Project	Seniors Living Development 7-9 Brighton Road, Peakhurst & 21 Charles Street, Riverwood
Report	Access Report
Reference	220578-Access-r6
Date	06 November 2023
Client	SARM Architects Kim Howell
Contact	khowell@sarm.com.au

Figure 1 Ground Floor Plan Revision E

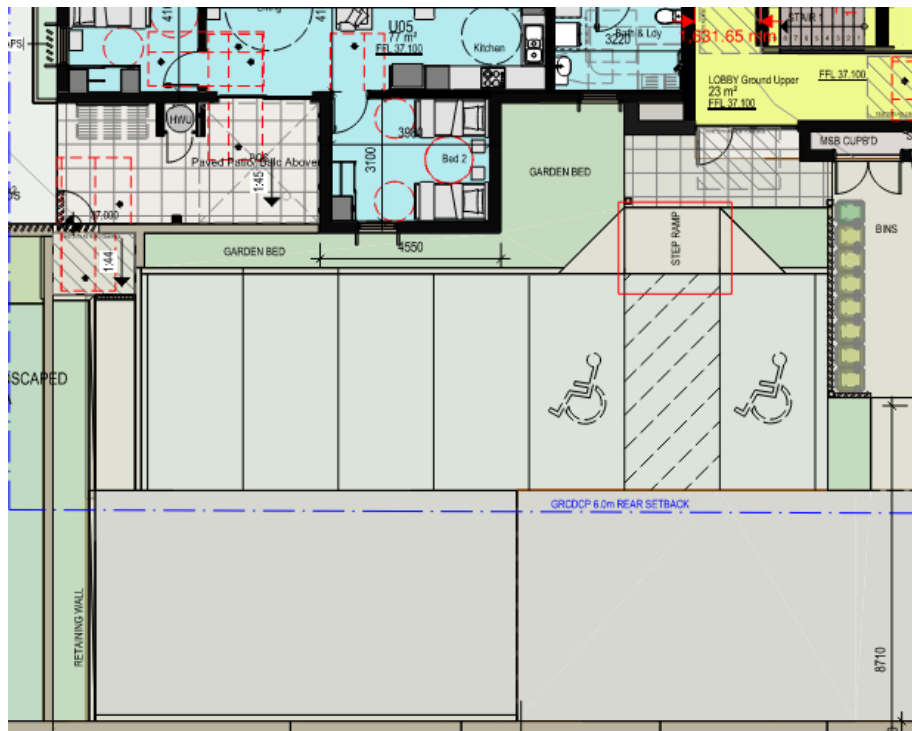
On review of the proposed car parking at the rear side of the allotment, only two (2) accessible carparking spaces have been provided in lieu of all car parking (not being car parking for employees) being provided to meet the requirements of AS 2890.6. The development drawings will be required to be updated to clarify the non-employed carparking that is required to comply with AS 2890.6.
